## Response to the Reviewer #1

*The authors present a new algorithm to retrieve OCIO from measurements of the TROPOMI satellite instrument. Overall, the paper presents valuable information and recommended DOAS settings for OCIO retrievals from space that deserves to be archived. I believe the paper should be published in AMT. The authors present convincing comparison between TROPOMI and ground-based OCIO SCDs, which clearly demonstrate the value of the satellite dataset. The authors present a number of tests and new settings. Some of these are new and make a lot of sense. However, the impression is also that many complication is introduced that is not really necessary. What is missing is a summary of the retrieval settings and choices that has the largest impact on the accuracy. The English is not very good and could be improved.*

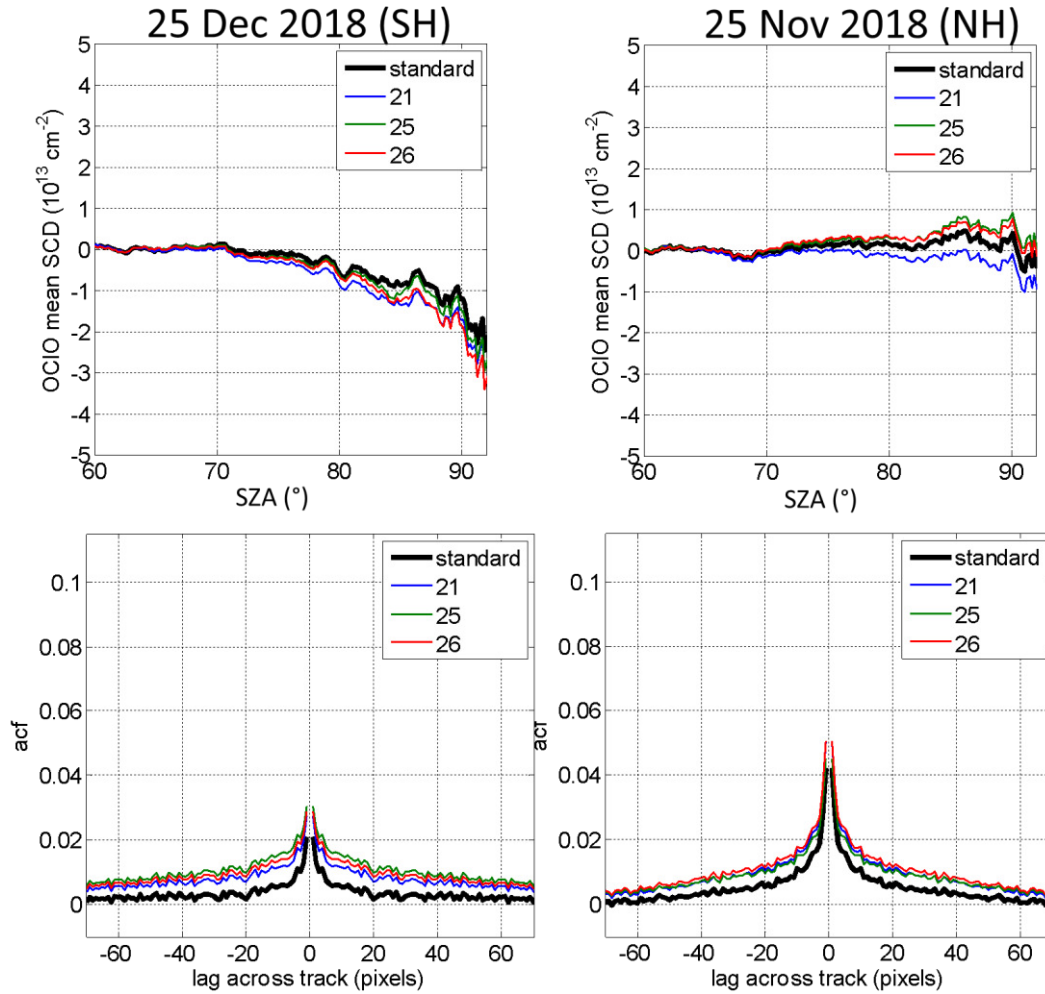
*-the description of the Ring effect is unclear. It is explained that Ring spectra are calculated at 2 Temperatures from the reference spectrum. Do you mean the reference for SZA 60-65°? If yes, I don't understand how it is calculated. Are the 4 Ring cross-sections fitted?*

The Ring spectra are calculated from the mean earthshine reference, as it would be calculated from a Sun spectrum. The Ring spectra calculation from the earthshine reference corresponds to the earlier research referenced in the study (e.g. Kühl et al., 2004b, 2006, 2008) Yes, all 4 Ring cross-sections are included in the fit.

We have also performed a test using measured Sun irradiance spectra for the calculation of the Ring spectra but did not find an improvement. Also the use of the Ring spectrum as defined in the S5P+I product does not provide an improvement. For illustration see Fig. R1.

We also made this more clear in the text: “The Ring effect is accounted for by Ring spectra calculated at two temperatures (280K and 210K) in order to account for dependency of Ring structures on temperature, which we found is important (see Appendix B9). The two Ring spectra are calculated from the Earth-shine reference spectrum and included in the fit. Each also is scaled with  $\lambda^4$  according to Wagner et al. 2009 (additional two spectra). The use of an Earth-shine reference spectrum for the calculation of the Ring spectrum is in accordance with previous studies (e.g. Kühl et al., 2004b, 2006, 2008) and is found to give a slight improvement with respect to the calculation of the Ring spectra from measured Sun irradiance spectra.”

Fig. R1. The same as Fig. 9 (in the manuscript), with differences between TROPOMI OCIO SCDs of our algorithm (left plots) or the preliminary S5P+I data (right plots) with zenith sky OCIO SCDs measured at Kiruna (top) and Neumayer (bottom).

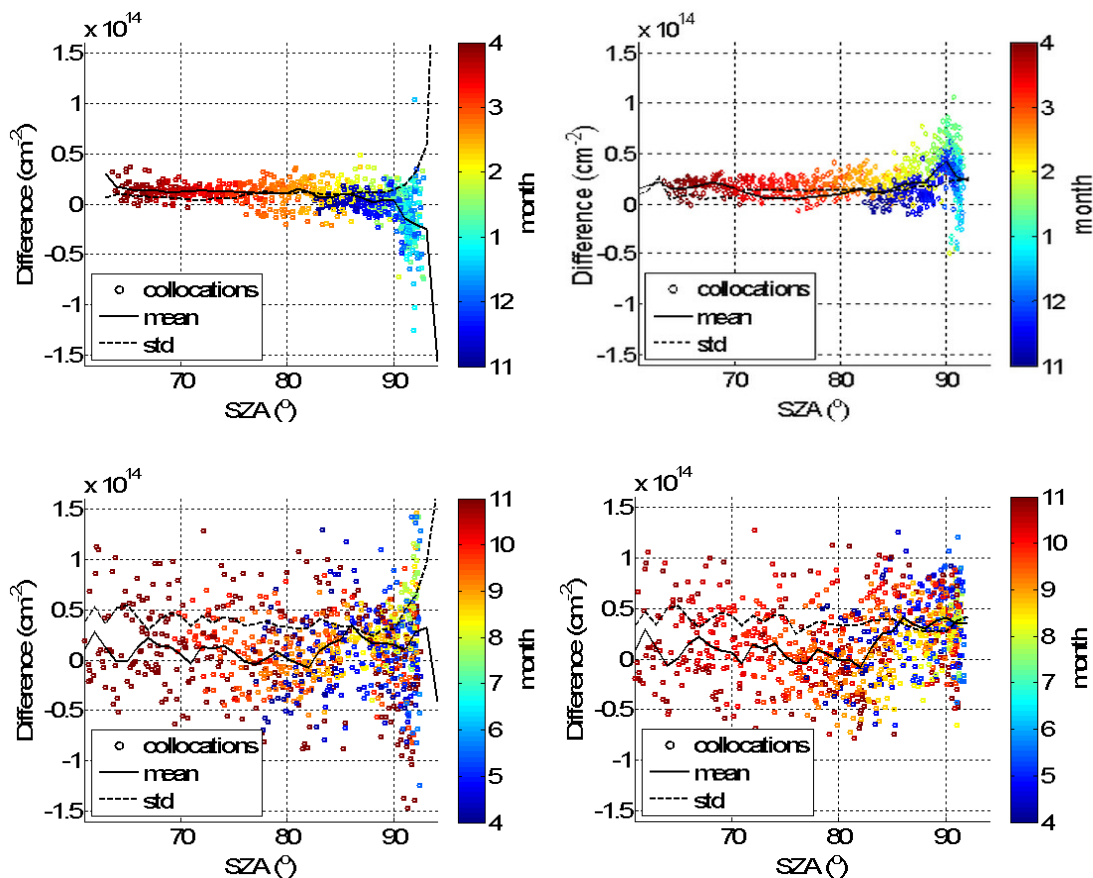
*My main concern is that the authors of this work claim that the new algorithm improves the retrieval results, but looking at the comparison between SP5+I and the results of this work, can that be really stated? The new algorithm takes into account several fine effects that, in principle, should improve the OCIO SCDs retrieval and decrease the corresponding errors. But, in practice, how can we say that the results of these work are better than those of SP5+I? For high SCDs, results are very similar, and for low SCDs the offset between both datasets cannot be explained. It is true that, as the authors explained, OCIO observation is not expected when the temperatures are still warm, as it is observed in the results of this study (Figure 10). Contrarily, SP5+I results show a background level of OCIO. But, it can be affirmed that the results of this work are better than those provided by the SP5+I? Did the authors compare the results of both algorithms with independent measurements (as those of Kiruna or Neumayer)? Please, explain better.*

We found that the differences in the agreement of the TROPOMI datasets with the ground based data are limited to high SZAs for time periods with low OCIO. Fig. R1 shows that the discrepancies for the S5P+I data are larger than those of our algorithm in comparison with the Kiruna data. The reason for this finding is that generally lower OCIO SCDs are observed in Kiruna than for Neumayer where, due to many days with very high OCIO SCDs, a much better overall agreement is achieved.

We will add/modify the statement about the discrepancies in the manuscript in the last paragraph of Sect. 4: “A comparison of S5p+I OCIO SCDs with the ground based data (not shown here), performed in the same manner as the comparison in Sect. 3 between this study and the ground based data, showed generally a very similar agreement between S5p+I and the

ground based data. Larger differences between the S5p+I OCIO SCDs and the ground based data than for our analysis was found for observations at high SZAs with low OCIO SCDs, thus consistent with the findings in this section. As a consequence, the application of the solar irradiance instead of the earthshine spectrum as Fraunhofer reference cannot likely explain the differences because it would provide a similar offset for all SZAs. Also the use of a Ring spectrum as defined in the S5p+I preliminary product (not shown here) did not provide a better result. Thus we can speculate that the differences could be related to the usage of different fit windows, together with still uncompensated higher order effects in the current version of the S5p+I OCIO fit as the consideration of the wavelength dependency of fit parameters becomes more challenging in larger fit windows. The differences might also be related to the implementation of the empirical terms in the S5p+I retrieval or instrumental effects, but such detailed investigations are beyond the scope of this study.”
